**APPLICATION NO. A/NE-TK/837 FOR PERMISSION
UNDER SECTION 16 OF THE TOWN PLANNING ORDINANCE**

Section 16 Application No. A/NE-TK/837

Annex 1 - Response to Comments Table

Section 16 Application for Temporary Public Vehicle Park (Private Cars Only) with Ancillary Electric Vehicle Charging Facilities and Ancillary Solar Panels and Associated Filling of Land for a Period of 3 Years at Lot No. 241 in D.D. 23 at Ting Kok, Tai Po, New Territories

Annex 4 : Swept Path Analysis

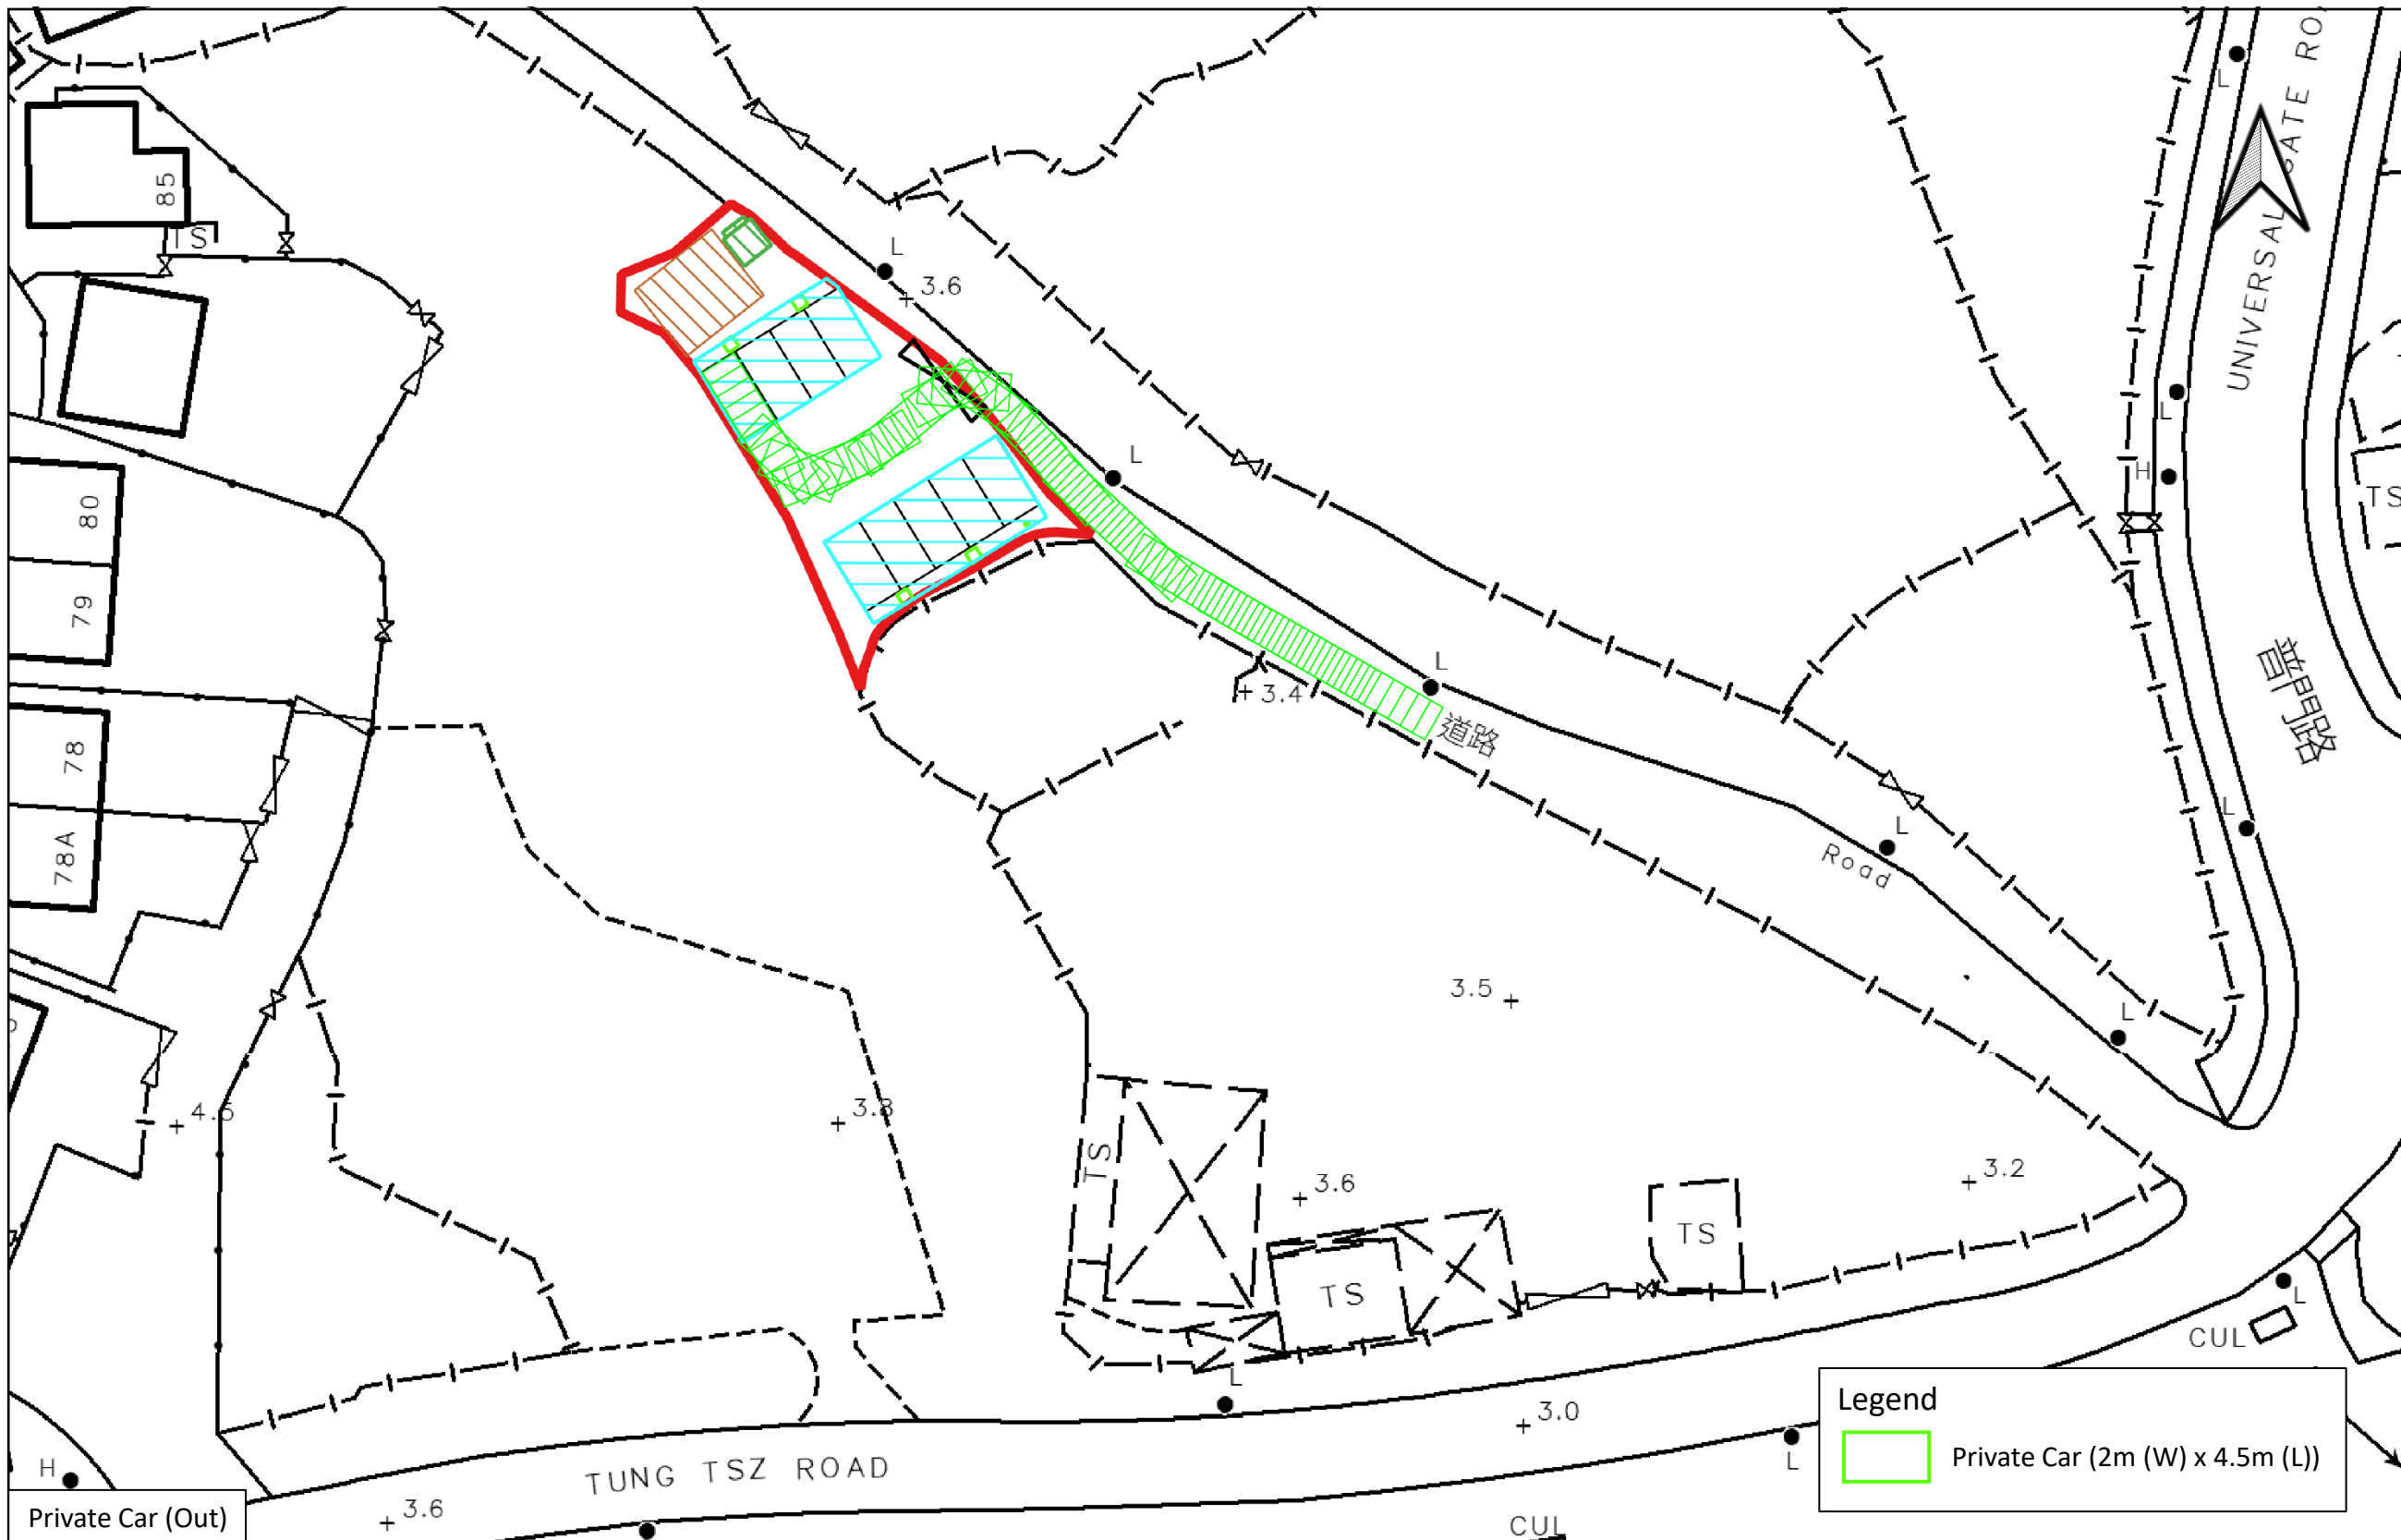
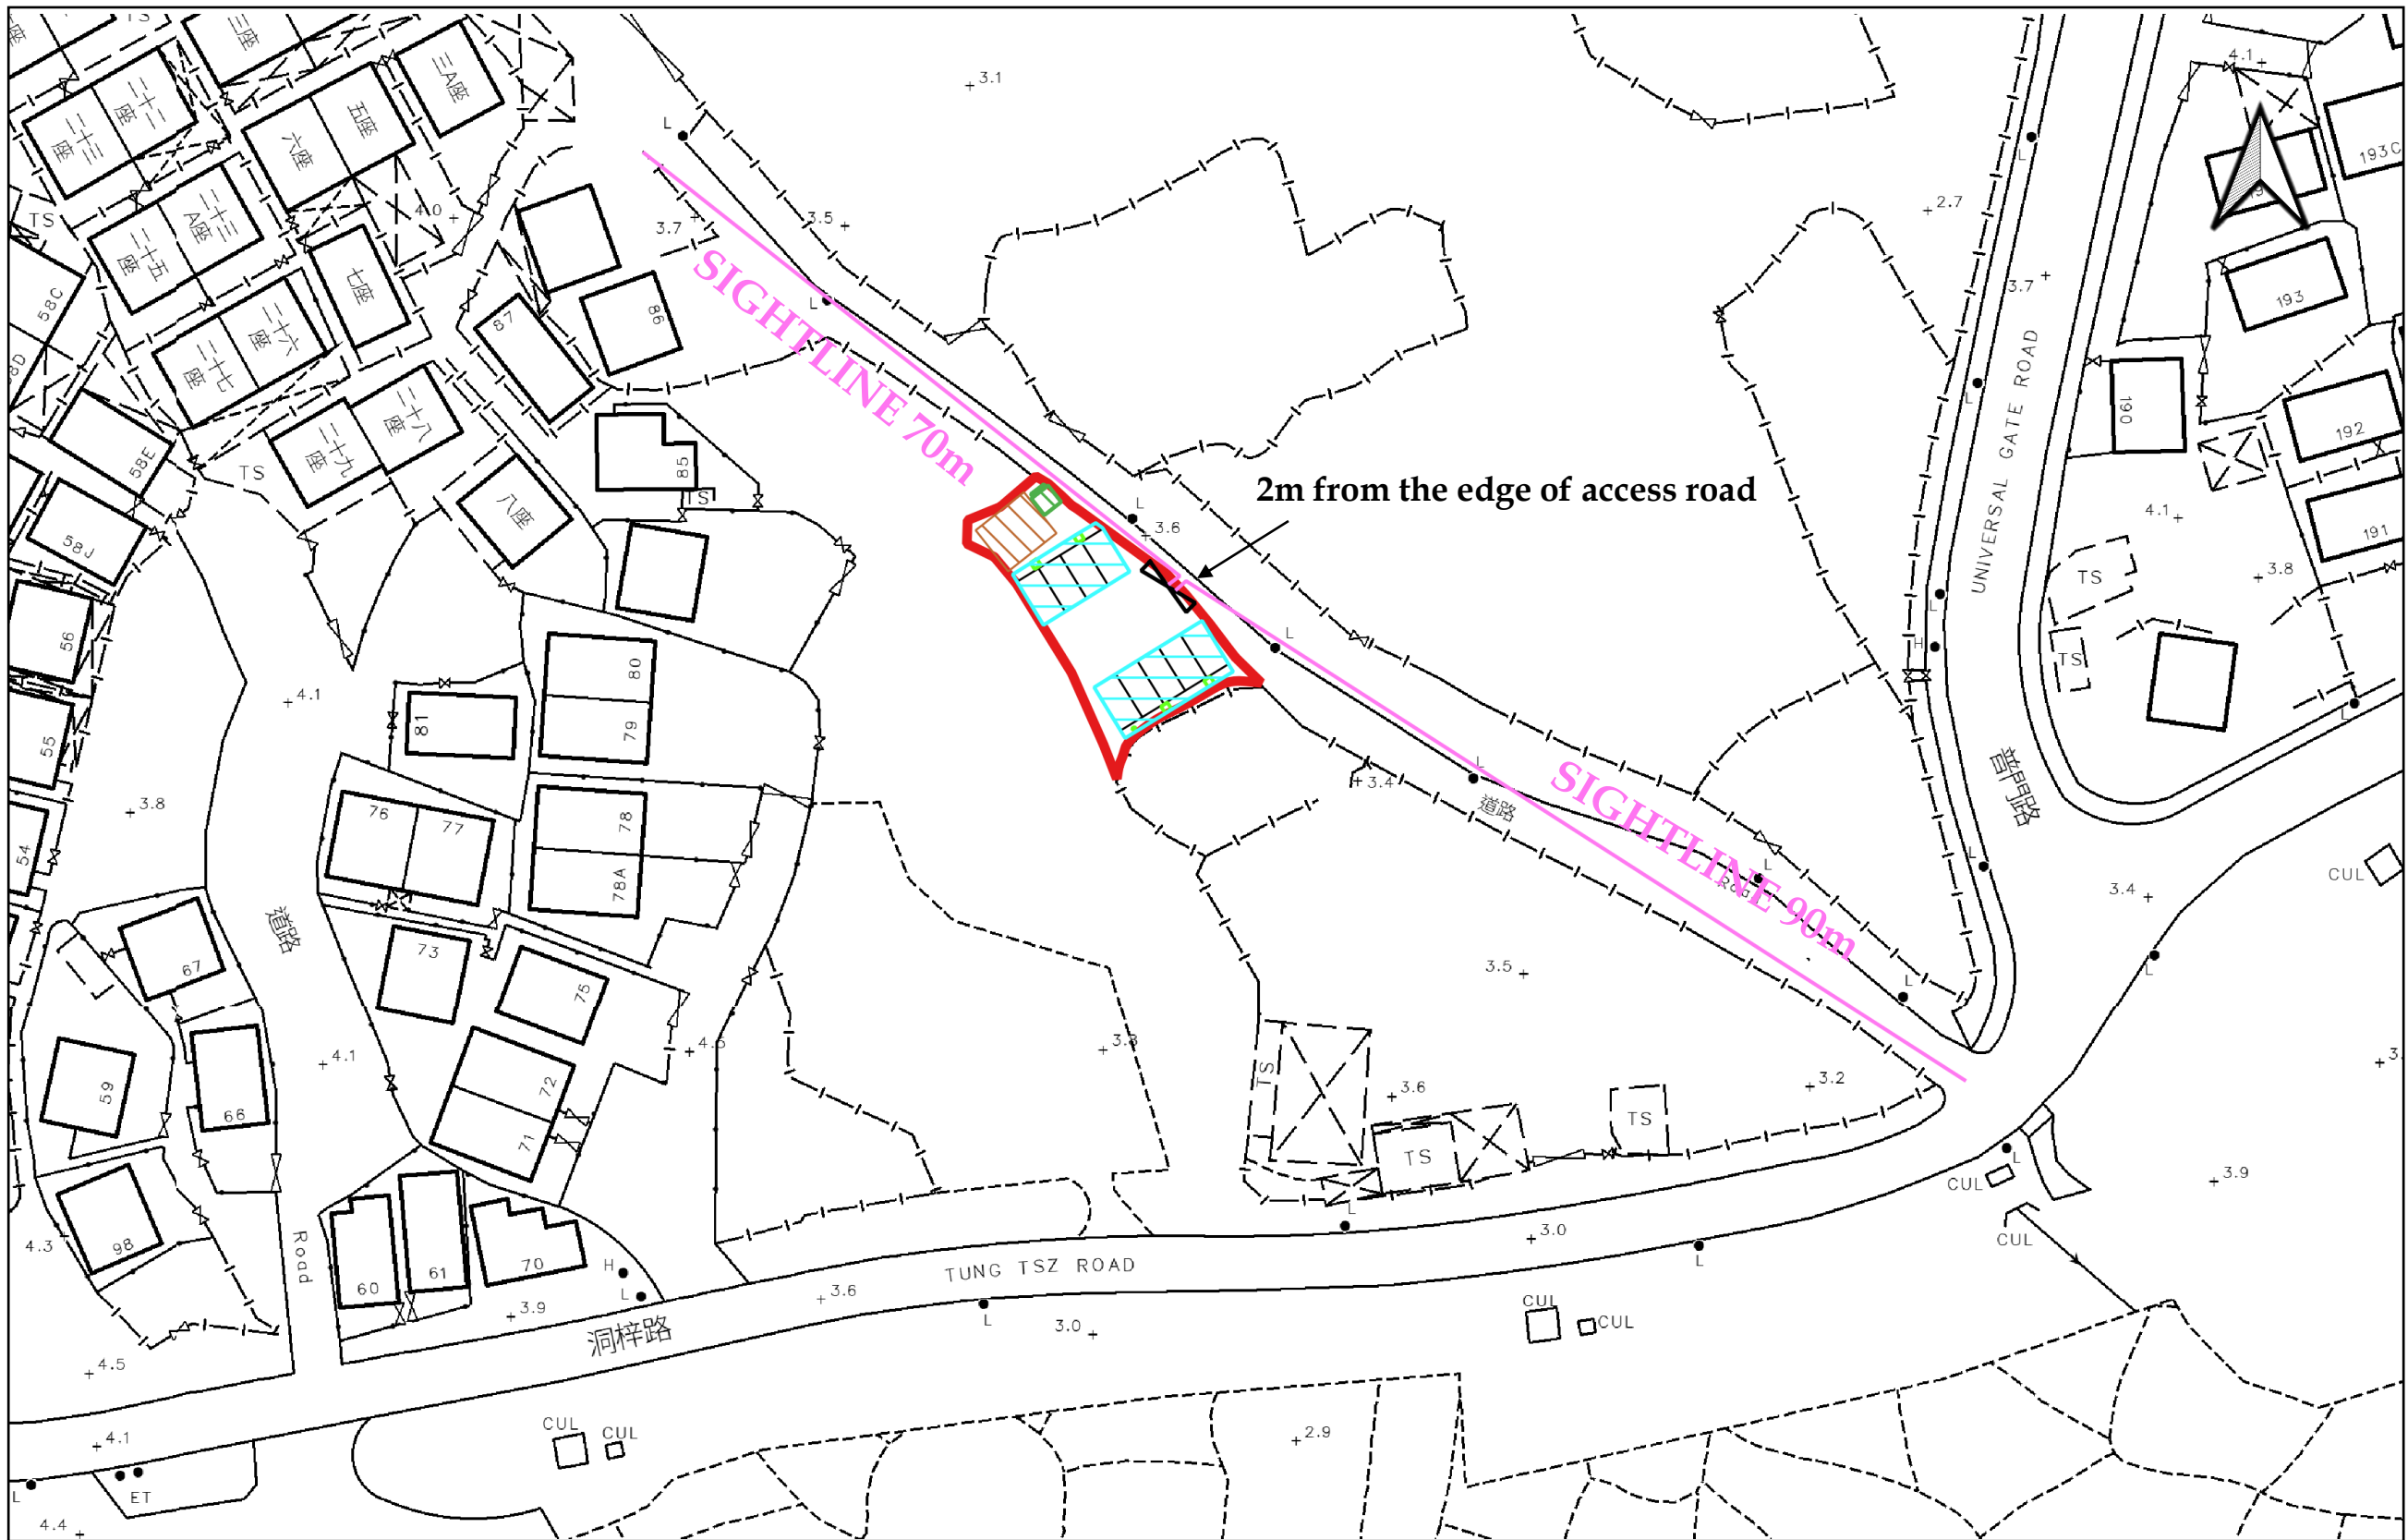
o	There are limited maneuvering spaces within the site and the adjacent local access, swept path analyses for the vehicles at other parking spaces shall be provided to demonstrate the practicability.	The indicative layout plan and the corresponding swept path analysis in Annexes 2 and 4 have been revised, demonstrating that there will be sufficient space for maneuvering within the site and the adjacent local access.
p	The swept path analyses reveals that reverse steering is required to park the vehicles, the applicant shall review and propose management measure to reduce the risk due to frequent reverse steering on the local access and within the site.	Noted, the revised swept path analysis in Annex 4 has demonstrated that there will be sufficient space for reverse steering manoeuvres within the site. To further mitigate associated risks, management measures such as the provision of highly visible signage and ground markings will guide drivers during reverse steering. In addition, regular monitoring and reviews will be
